**Proposed EV Mobility City with Ancillary Staff Quarters and
Talent Accommodation at Various Lots in D.D. 51 and
Adjoining Government Land, Fanling
(Application No. Y/FSS/20)
- Further Information No. 3 -**

**S.12A Amendment of Plan Application
Proposed EV Mobility City with Ancillary Staff Quarters
and Talent Accommodation at Various Lots in D.D. 51 and
Adjoining Government Land, Fanling**

(Application No. Y/FSS/20)

Comments	Responses
Comments from Environmental Protection Department (Contact Person: Ms. Trista LAU; Tel: 2835 1152)	
1. the applicant shall confirm noise generating activities would be located away as far as possible from any noise sensitive receivers (esp. the nearby Fanling Area 48 public housing sites) and within the enclosed building. Also, pls. confirm whether noisy operations during sensitive hours (e.g., 11pm to 7am) will be prohibited;	The Proposed Development, which mainly focuses on clean energy and EV, as well as R&D works, is non-polluting in nature. Unlike conventional factory (e.g. car manufacturing), noise impact on the surroundings during operational stage is not expected. Noise generating activities, if any, would be located within the enclosed b

**Appendix 3.4 Extracted from Engineering Feasibility Study Report for
Proposed Public Housing Development at Area 48, Fanling
(PHD48)**

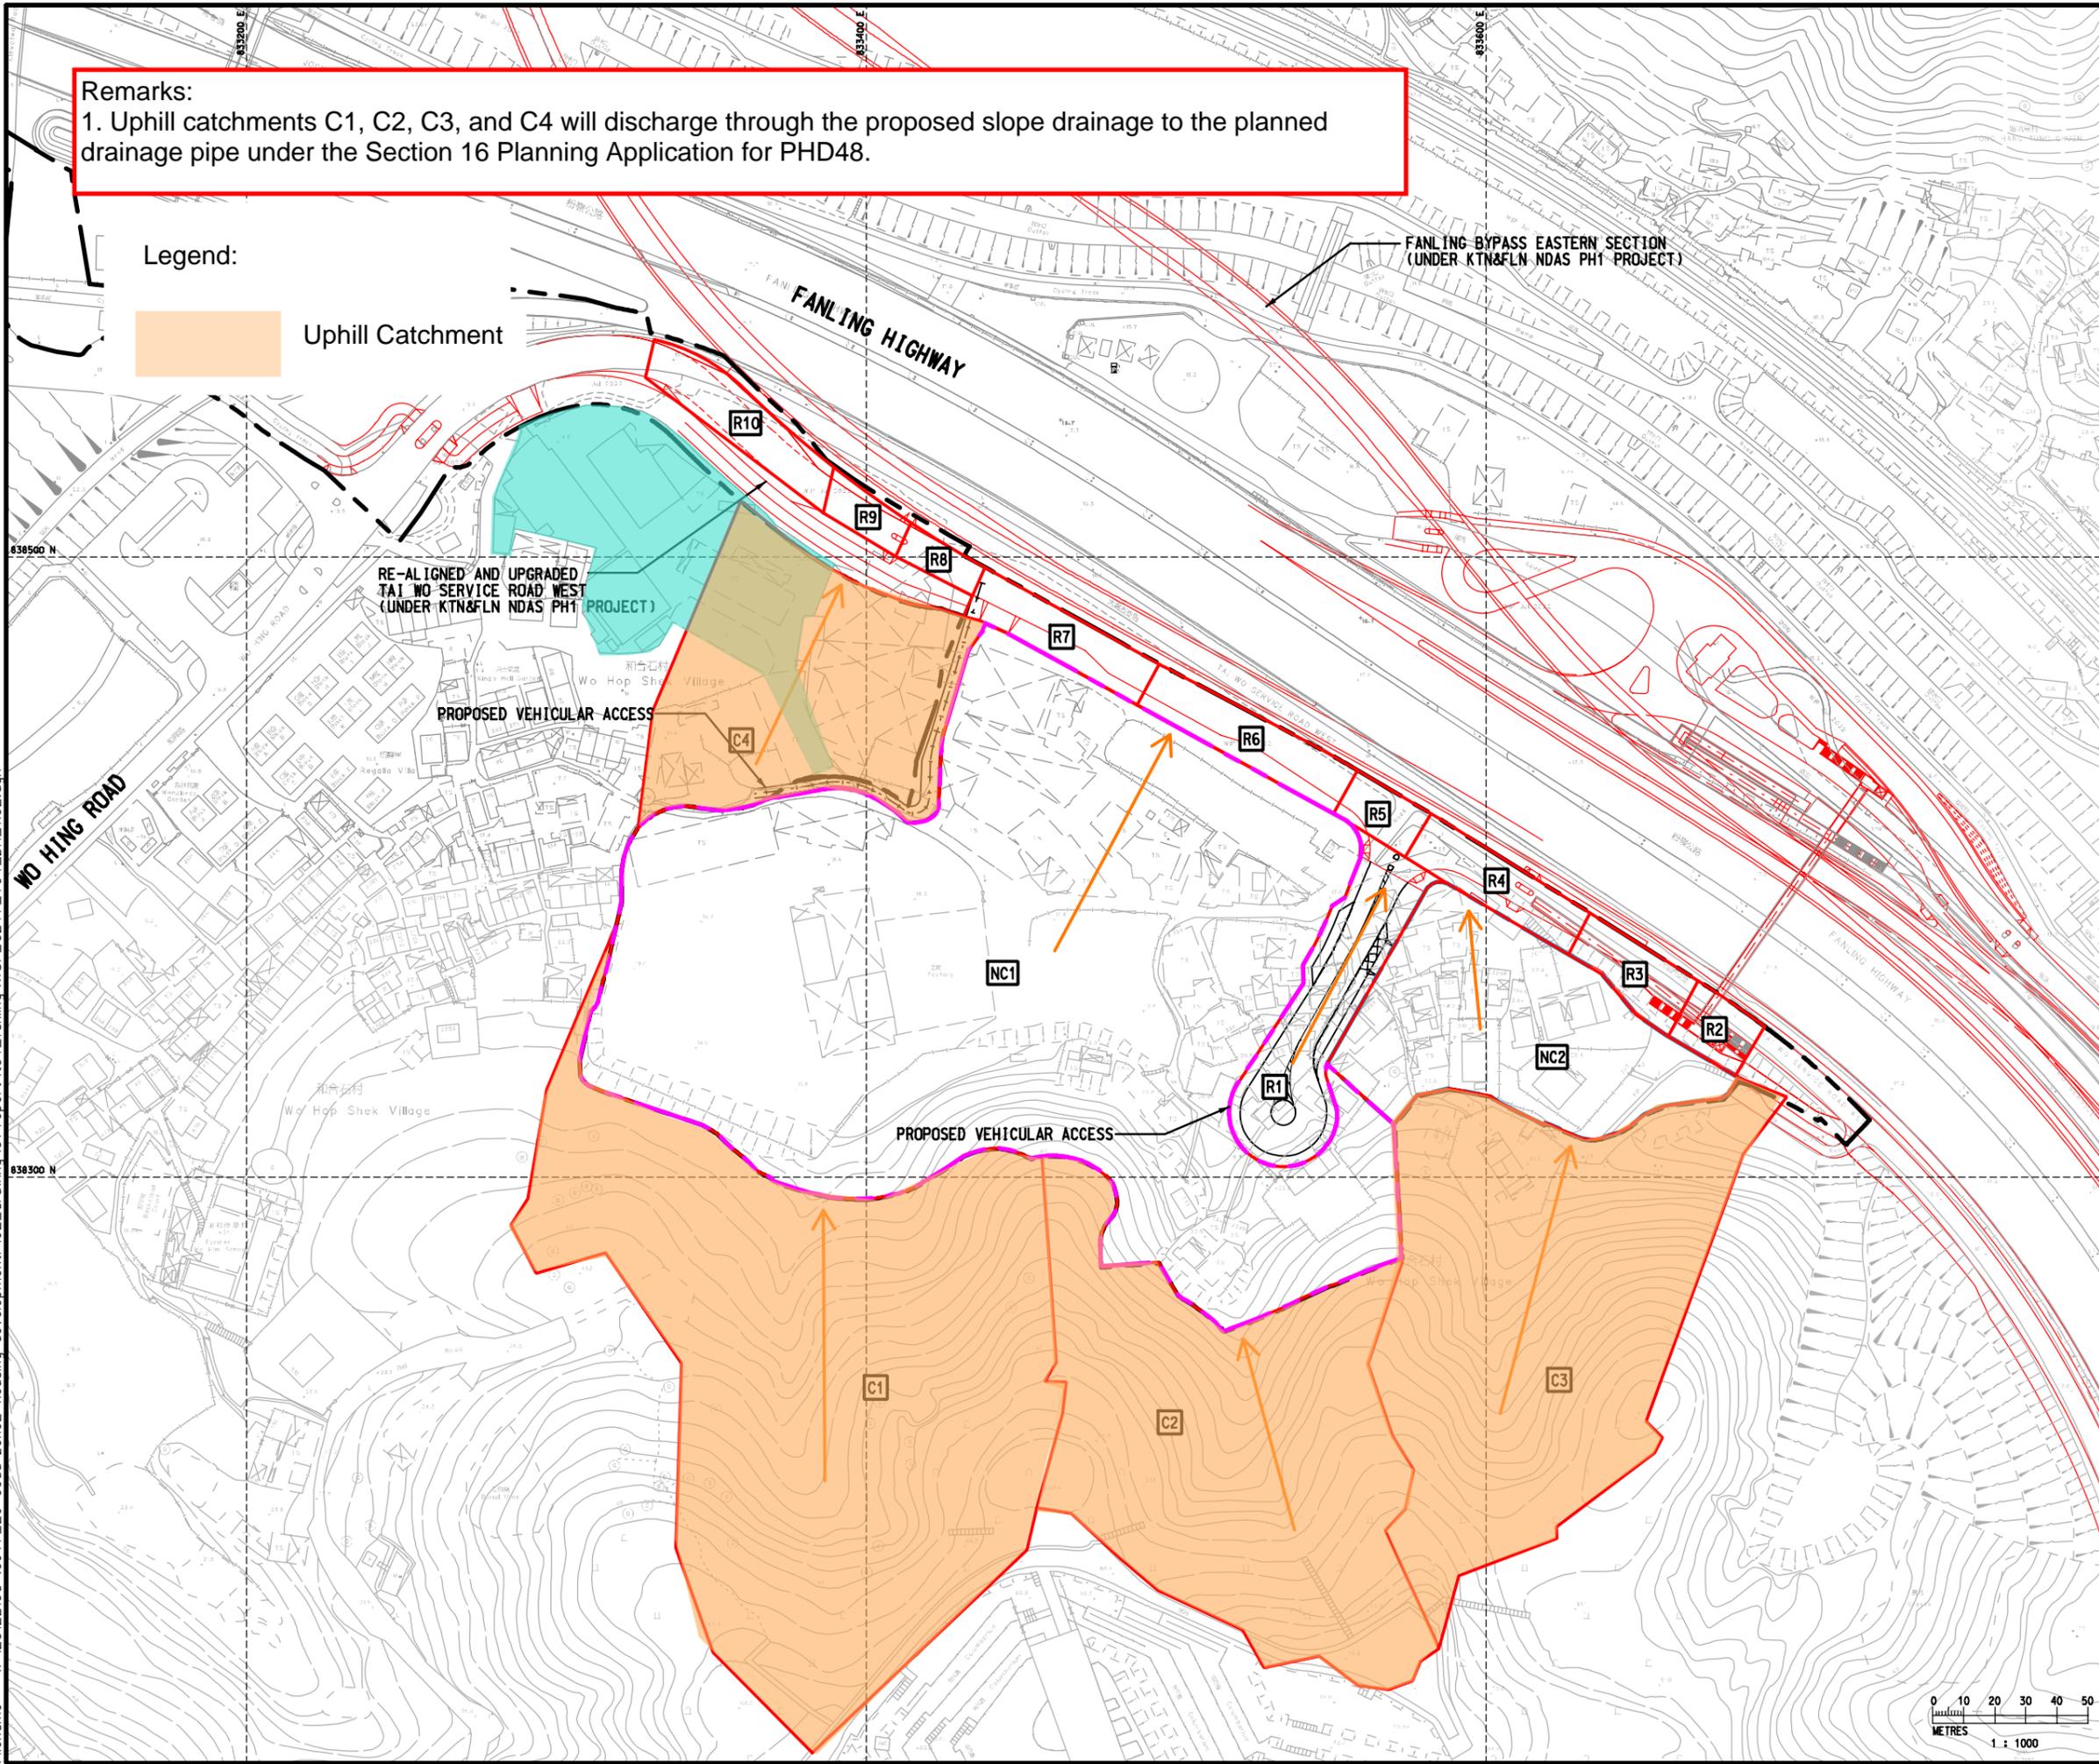
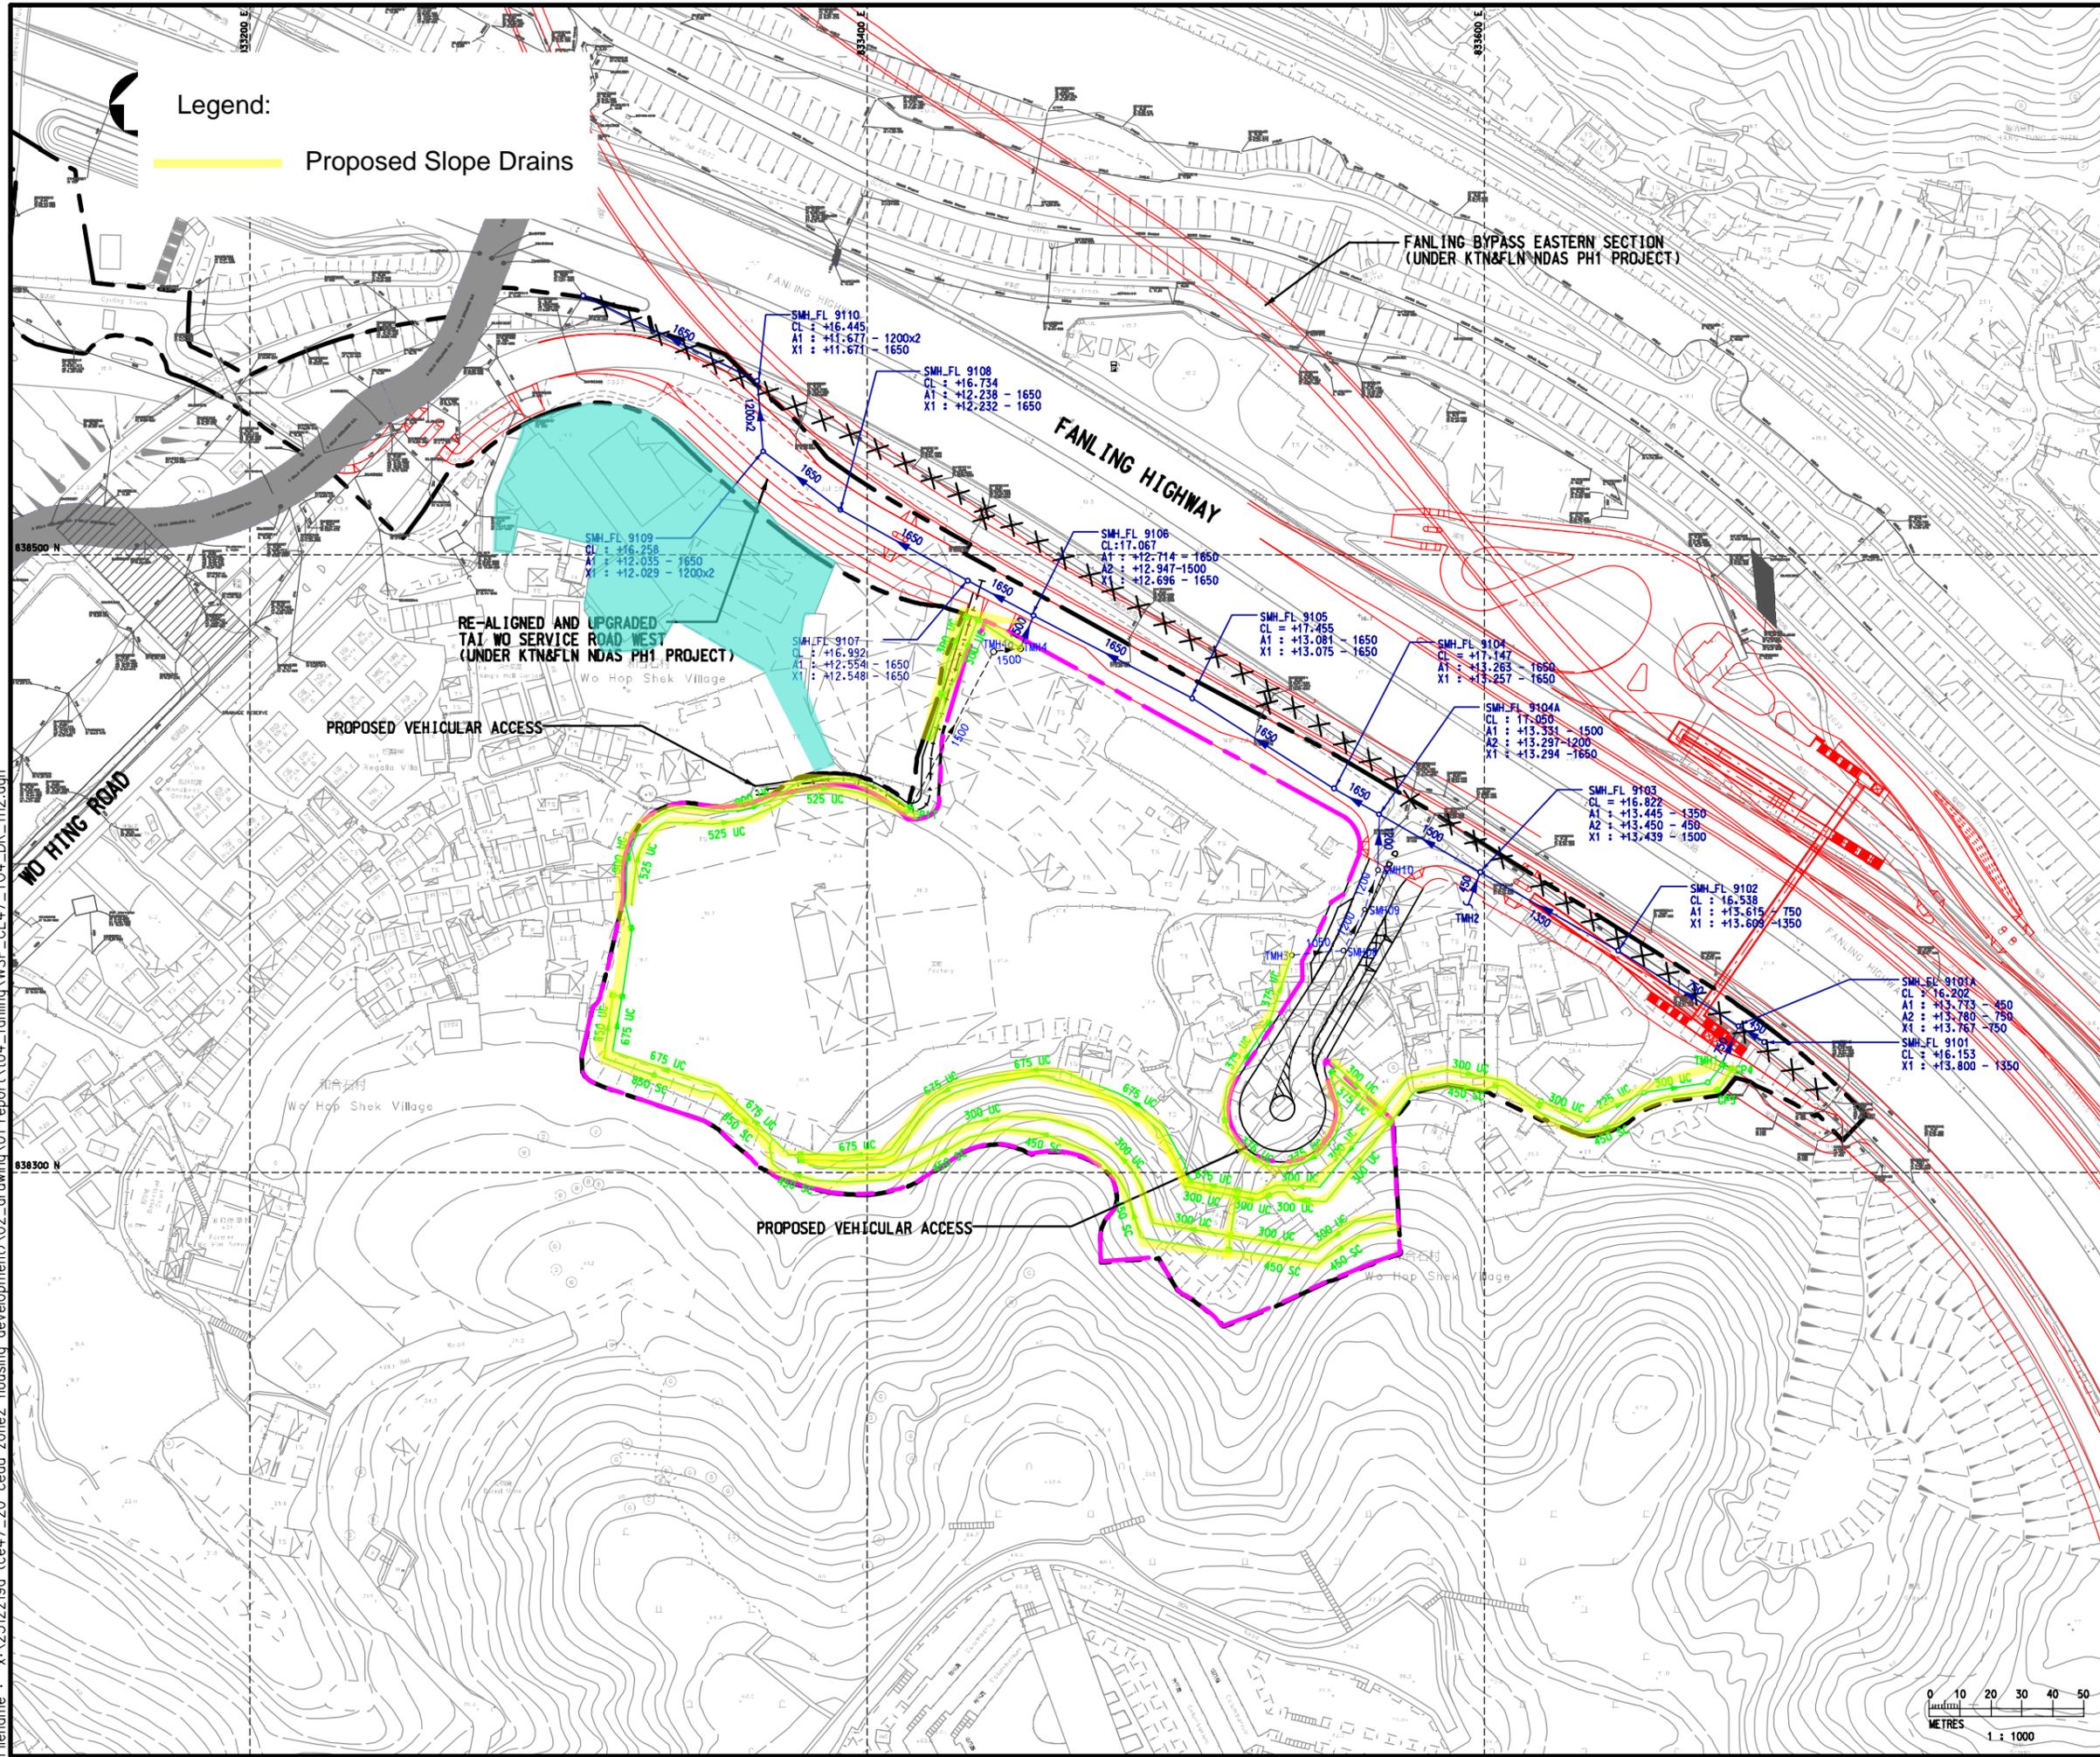
Comments	Responses
<p>the adjacent catchment areas or adversely affect the existing drainage system.</p>	
<p>3. Appendix 3.4 and Section 2.1.3:</p> <ul style="list-style-type: none"> • Please indicate the concerned "uphill catchment" and associated slope drains in Appendix 3.4. • Please provide more detailed description of the proposed internal drains within the site (e.g. alignment, dimension, catchment delineation, capacity check, discharge points, etc. • Please include site photos of the existing drainage system within the site for our reference. 	<ul style="list-style-type: none"> • The uphill catchment and associated slope drains have been indicated in Appendix 3.4. • A peripheral drainage channel has been proposed within the Application Site. The proposed alignment is presented in Figure 2.1, and the corresponding hydraulic calculations have been updated and provided in Appendix 2.1. • According to the site survey, there is no drainage system observed within the Application Site. Please refer to the newly added Appendix 1.1.

- 2.1.4 According to the preliminary drainage impact assessment of the Approved Section 16 Planning Application for PHD48, a slope drains will be proposed to receive the surface runoff from uphill catchment (shown in **Appendix 3.4**). Therefore, it is anticipated that there is no surface runoff from uphill catchment will be flow into the Application Site.
